MUL-T-LOCK®

ON LINE UPDATE

Tech. Update

No. 233

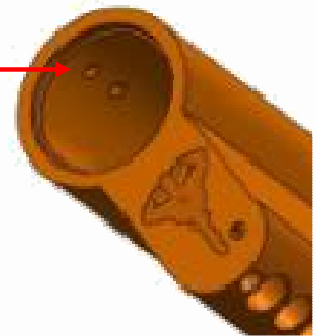
The new product is backward compatible – mainly meaning that new patented keys (pending at present) will work with older cylinders – but old keys will not work with new cylinders.

The same situation occurs with cylinder bodies (new will work with "old" but old will not work with new).

- Cylinder body has two partial drillings at the top  and can be used with old and/or new plugs (also classic)
- Additional identification will be a "+" (instead of "I") mark appearing next to the date of production marking (i.e. 3511+)
